Subject: Response to NOI Comments

Project: **Town of Reading | Birch Meadow Phase II**
Project No. 24037.00

Date: 16 April 2025

TREE PROTECTION AND REMOVALS PLAN

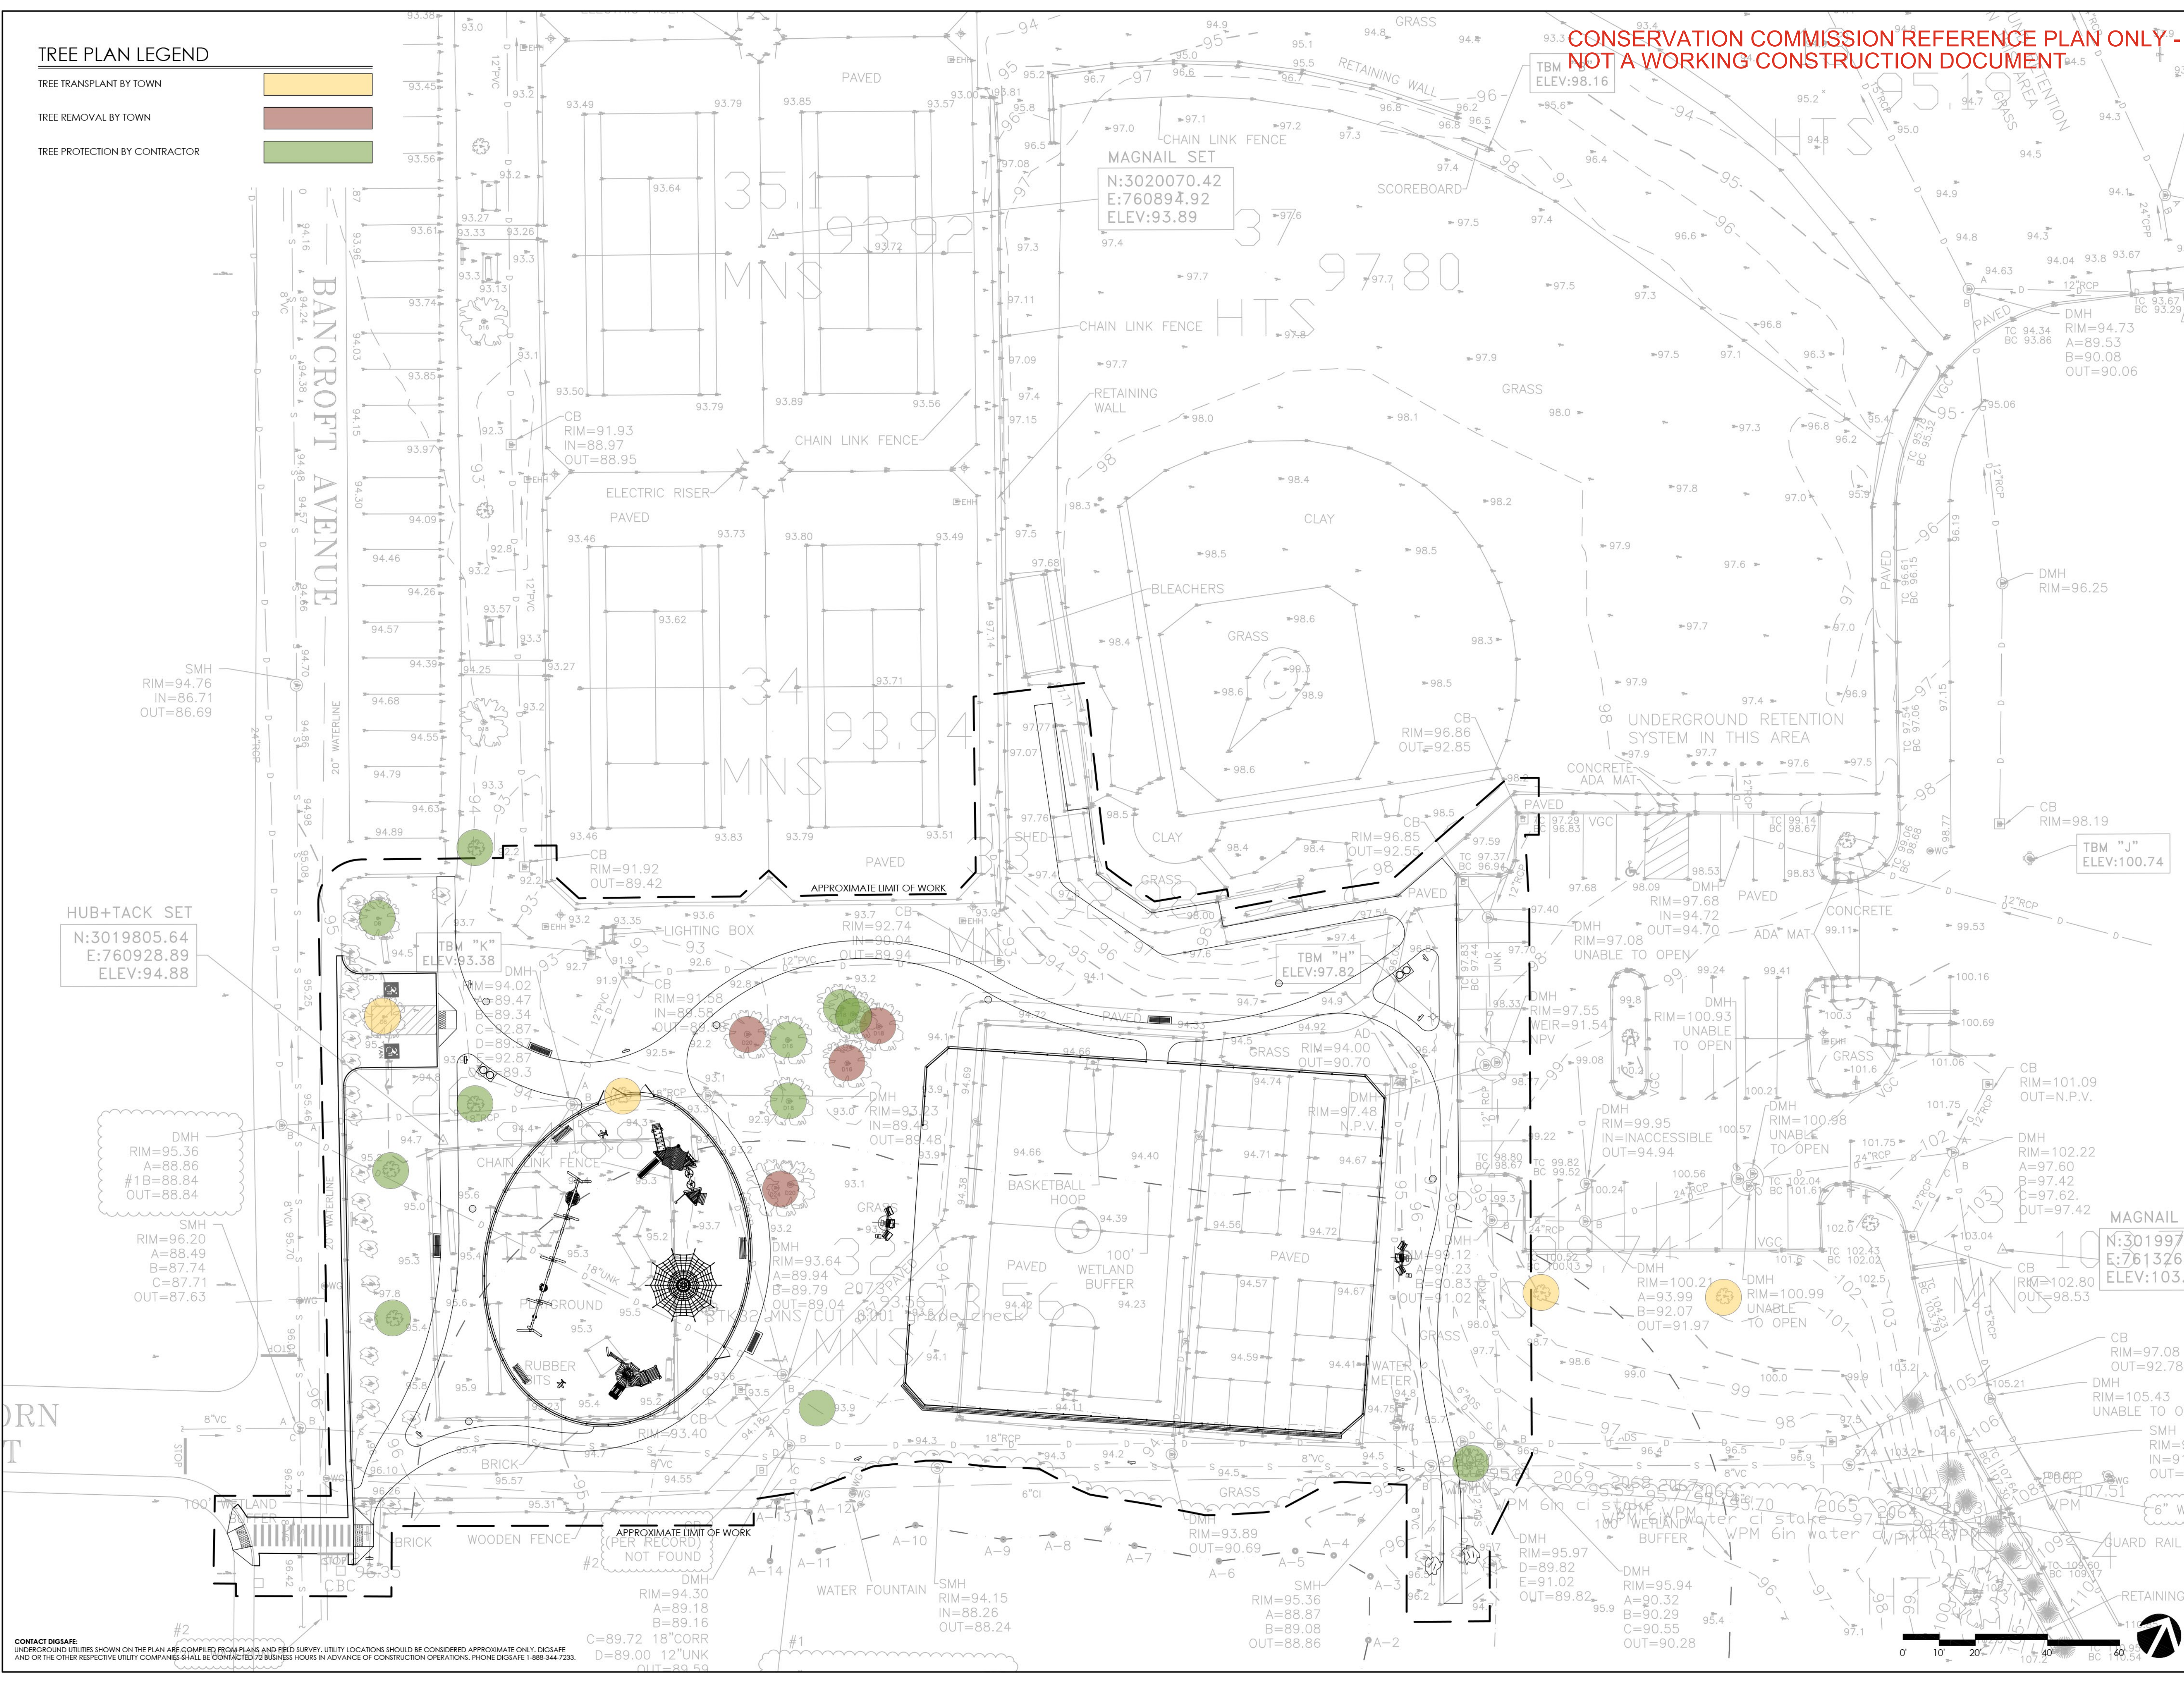
Revise Site Preparation Plan to identify trees to be removed, transplanted, or protected.

The Site Preparation Plan has been revised to better indicate which trees will be removed, transplanted, or protected as part of the project. An additional plan specific to tree removals has also been provided.
